From: [Tim Foley](#)
To: [Lia Niebauer](#)
Subject: [EXTERNAL]BAR Comment
Date: Tuesday, September 28, 2021 9:16:37 PM

From: [Terence Flanagan](#)
To: [Lia Niebauer](#)
Subject: [EXTERNAL]101 Duke Street plan
Date: Wednesday, October 6, 2021 6:42:45 PM

From: [Ana Gomez-Acebo](#)
To: [Lia Niebauer](#); [William Conkey](#)
Subject: [EXTERNAL][10.20 BAR Meeting]: Docket 9 & 10 | Ana Gomez-Acebo Written Statement
Date: Wednesday, October 20, 2021 5:03:11 PM
Attachments: [image.png](#)
[Relative building heights \(2\).pdf](#)

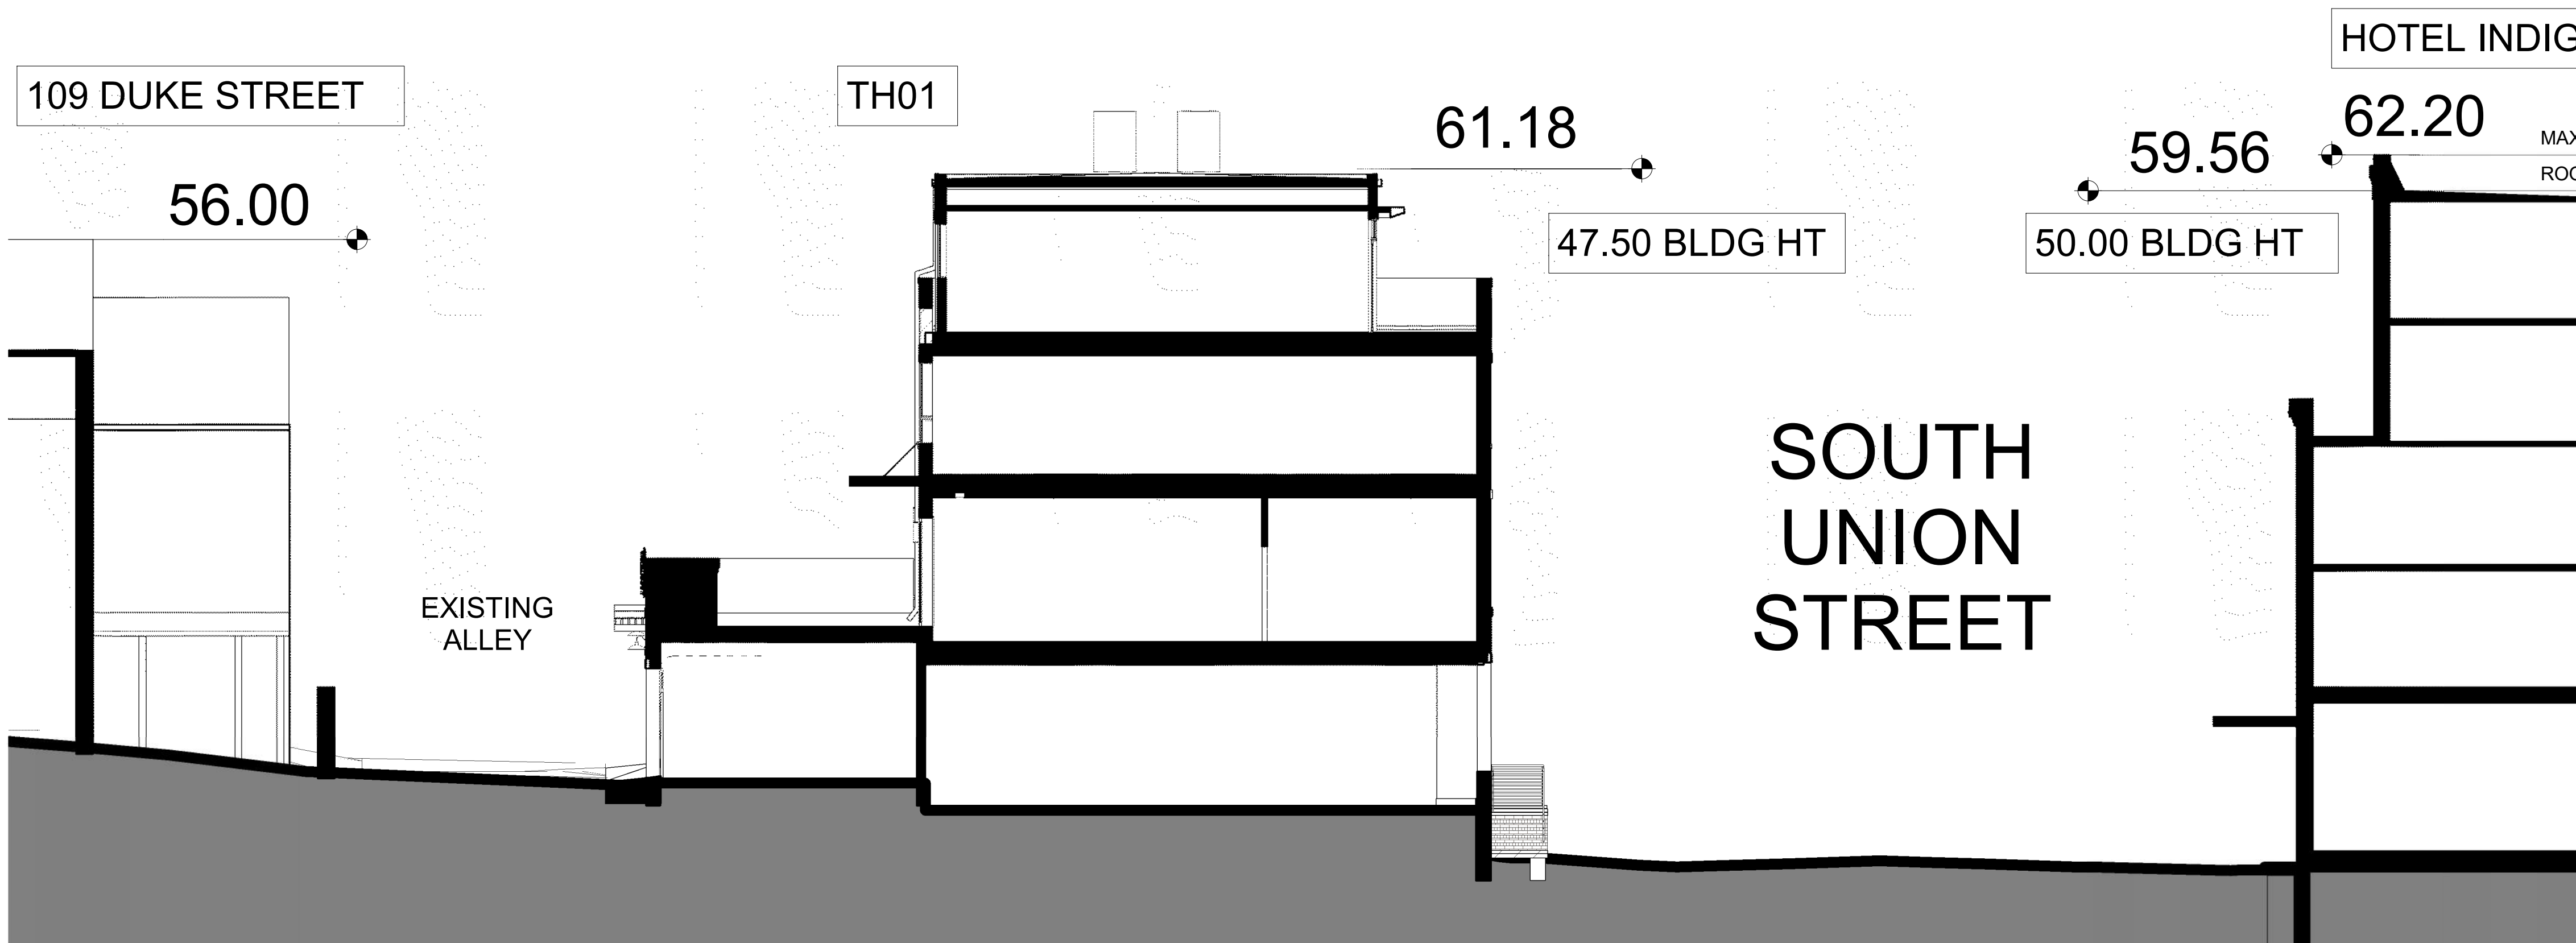
Duke Street is one of the most important streets of Old Town and the historic district and it should be treated like one. Just like Hotel Indigo respected Duke Street's residential corner by setting back the top **TWO floors on both Union Street and Duke Street at the same proportion** (See below image), this project is only setting back **ONE** floor on Union Street and **very slightly on Duke Street**.

1 SECTION THROUGH DUKE STREET @ 100 DUKE STREET
1/8" = 1'-0"

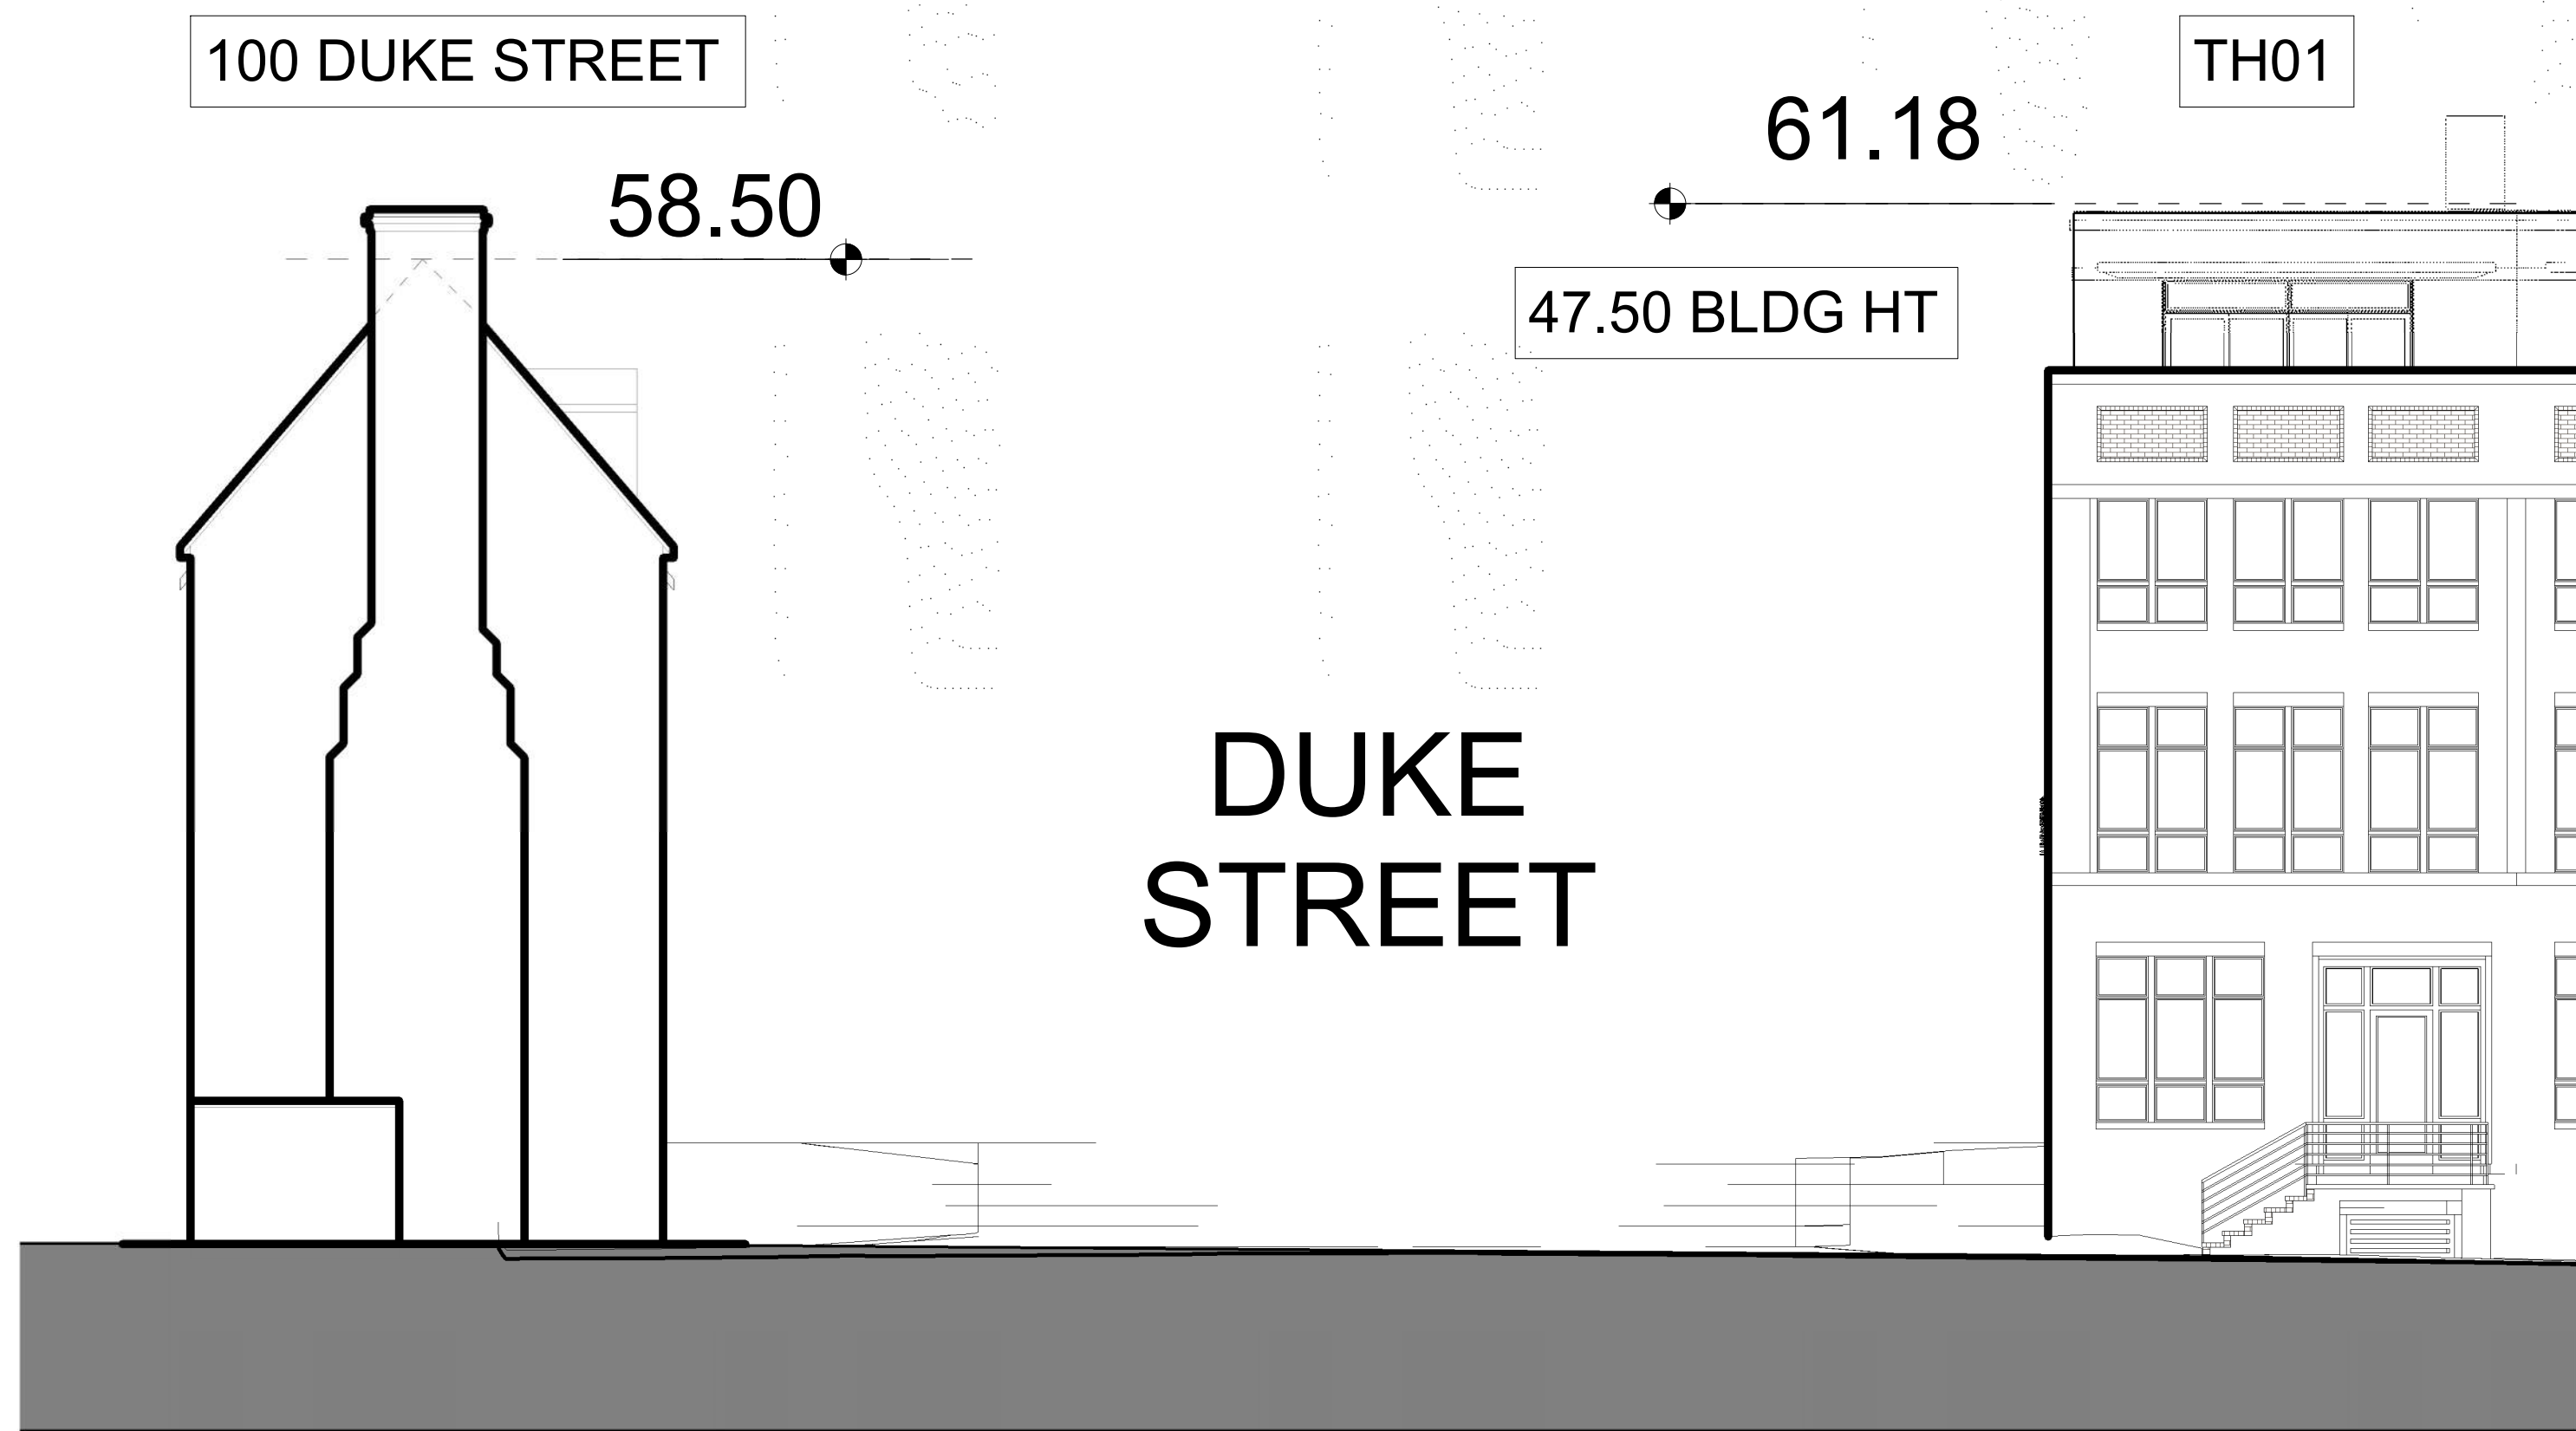
1. The height of a gable roof, such as 100 & 109 Duke Street, is actually measured at the midpoint of the roof, yet the applicant is erroneously measuring the height to the highest peak per the drawing. In addition to explicitly highlighting the height of the roof **peak** as 58.5 ft for 100 Duke and 56 ft for 109 Duke, the applicant should have **ALSO** included the height of the **bottom** of our roofs, and the **mid-point** measured in between. This level of specificity will help fix the blatant and misleading inaccuracies that exist today.

The 58.5 ft for 100 Duke's roof peak, 56.0 for the 109 Duke's peak, and the 61.18 for the proposed 101 Duke building all seem to be **height above sea level**, so they should be labeled as such. On the other hand, the 47.50 ft building height in parentheses seems to be the **height of the building above average finish grade**. Not only should this be labeled, but also the applicant should include Duke Street homes' heights above average finished grade, especially since City zoning regulations require building height to be measured above average finished grade, and to the midpoint for the gable roofs at 100 and 109 Duke. Because the drawing only has partial information, the project's 47.5 ft as height above average finish grade makes it seem like it has a **SHORTER** height compared to Duke Street homes, when it actually is **LOOMING** over my house, 100 Duke Street, and over 109 Duke Street.

Zoning regulations for 100 Duke Street allowed my house to be constructed to a maximum height of 45 feet tall and was/is not permitted to have a flat roof at even the 45 foot height, as proposed at 101 Duke. Combined with the increased elevation of the 101 Duke Street property, zoning allows 101 Duke to rise approximately 10 feet higher than my house and to be constructed with a **FLAT roof that adds to the mass and scale incompatibility**. Although the height of the proposed building is within the height allowed by the zoning ordinance for the Waterfront zone, those are absolute maximums of the zoning envelope. **The BAR has a responsibility to follow design guidelines that further direct that new buildings be constructed at a height, mass and scale and architectural character that are compatible with surrounding buildings, particularly those of historic architectural merit - specifically 109 Duke Street**, which is likely ~35 ft with an even lower approximately 25 ft tall addition that should also be labeled on the height comparison drawings. Let's take a step back and reflect on this comparison of 47.5 ft for 101 Duke vs. estimates of 35 ft and 25 ft. for the historic 109 Duke Street...
